DART SERVICE INSTRUCTION

TO AMEND INSTALLATION INSTRUCTIONS IIN-D119-827 REV. D OR LATER APPROVED REVISION AND
INSTRUCTIONS FOR CONTINUED AIRWORTHINESS ICA-D407-827 REV. 0 OR LATER APPROVED
REVISION

REF. FAA STC: SR02258SE
REF. TCCA STC: SH14-22
REF. EASA STC: 10049460
REF. ANAC STC: 2015S08-03

Figure 1 - DSI 9783-011 Lanyard kit Installation

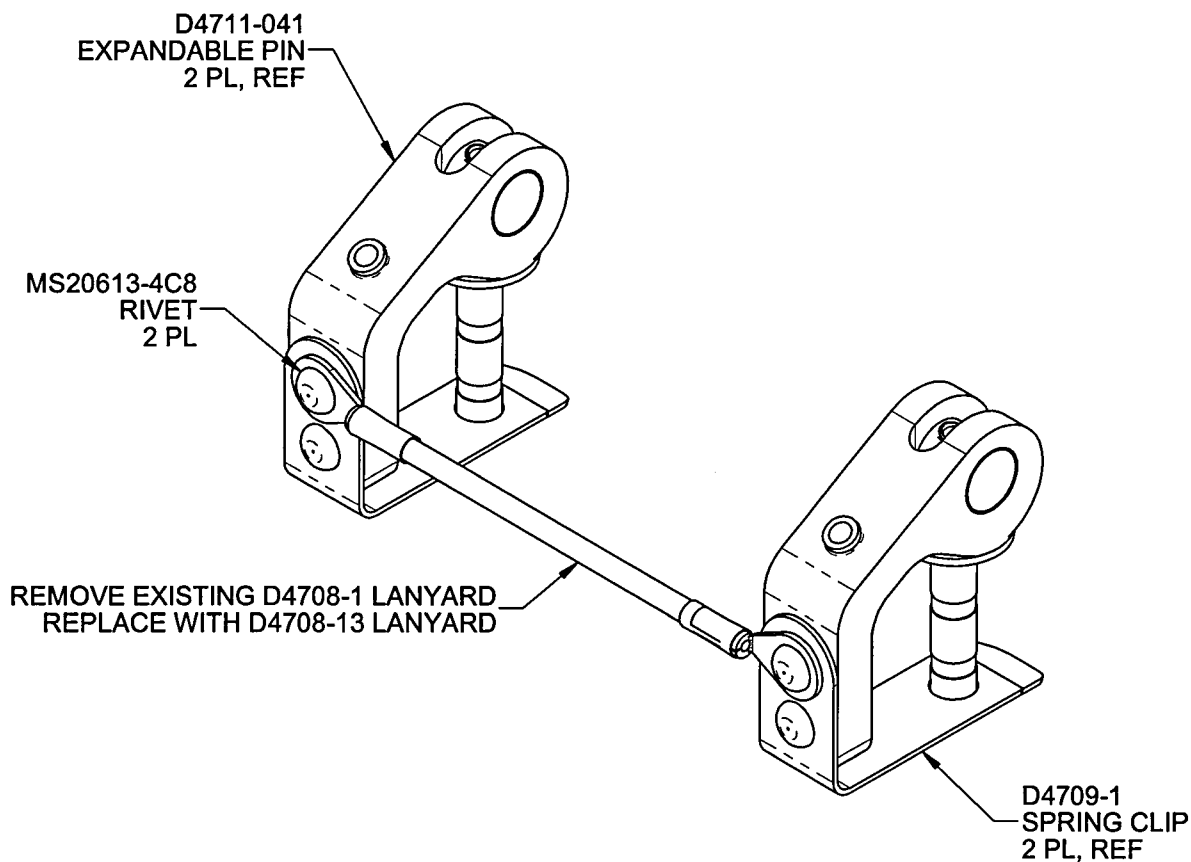
It has come to DART's attention that the D4708-1 Lanyards, which are part of the D4704-041 Expandable Pin Assy which are included in the D119-827-011 Pedal Lockout kit, may cause interference when installed on the Bell 206/407 aircraft models.

1. If installed, remove the D4704-041 Expandable Pin Assy from the aircraft per ICA-D407-827.
2. Remove 2X MS20613-4C8 rivets per Figure 1. Remove and discard existing D4708-1 Lanyard.
3. Install the D4708-13 Lanyard with 1X MS20613-4C8 rivet thru each of the D4711-041 Expandable Pins and D4709-1 Spring Clips per Figure 1.
4. Install the modified D4704-041 Expandable Pin Assy per ICA-D407-827.
5. Update the aircraft log book to indicate installation of the DSI 9783-011 Lanyard kit.

The purpose of this DSI is to provide instructions for the removal of the existing D4708-1 Lanyard and replacement with the D4708-13 Lanyard.
